Access Compliance Report Public Rights-of-Way (Curb Ramps)

Main Street: **BROOKWOOD_ST** Cross Street: **TERRASTAR_LN** Location: **N**

ADA ID: **RPAT211101094415** Ramp Type: **Type 4 - Parallel** Initial Pass/Fail: **Fail** Overall Compliance: **No** Severity Score: **2**

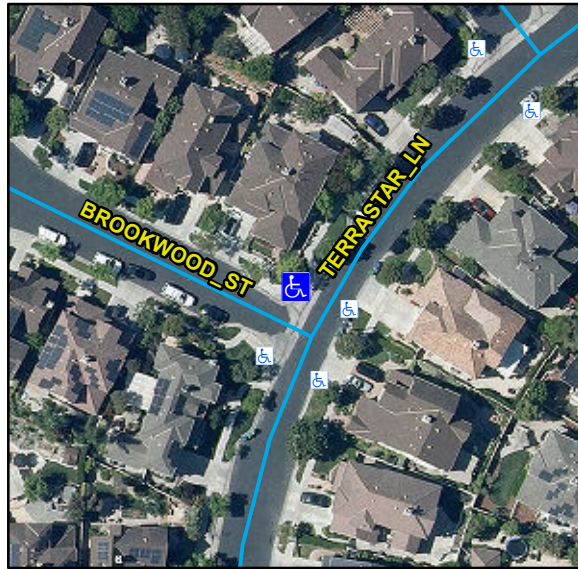
R204.3, R304.5.3, STD 1115

Compliance	Description	Data	Compliance	Description	Data
N/A	Ramp Length LT (in)	105	N/A	Ramp Length RT (in)	88
Yes	Ramp Width LT (in)	52	Yes	Ramp Width RT (in)	52
Yes	Ramp Run Slope LT (%)	6	Yes	Ramp Run Slope RT (%)	6.1
Yes	Ramp Cross Slope LT (%)	1.8	No	Ramp Cross Slope RT (%)	3.3
N/A	Landing Present	N/A	N/A	DWS Provided	N/A
N/A	Landing Length (in)	N/A	N/A	DWS Contrast	N/A
N/A	Landing Width (in)	N/A	N/A	DWS Length (in)	N/A
N/A	Landing Run Slope (%)	N/A	N/A	DWS Full Width	N/A
N/A	Landing Cross Slope (%)	N/A		DWS Offset Type	N/A
N/A	Landing Movement Obstructed?	N/A	N/A	DWS Offset Left (in)	N/A
	Landing Movement Type	N/A	N/A	DWS Offset Right (in)	N/A
N/A	Landing Shared	N/A			
N/A	Clear Space	Yes			
N/A	Clear Space To Crosswalk (in)	N/A			
N/A	Marked Crosswalk 1	No	N/A	Marked Crosswalk 2	No
	Crossing 1 Direction	SW		Crossing 2 Direction	SE
N/A	Marked Crosswalk 1 Width (in)	N/A		Marked Crosswalk 2 Width (in)	N/A

Remove & Replace Curb Ramp With Two New Directional Ramps or Equivalent.
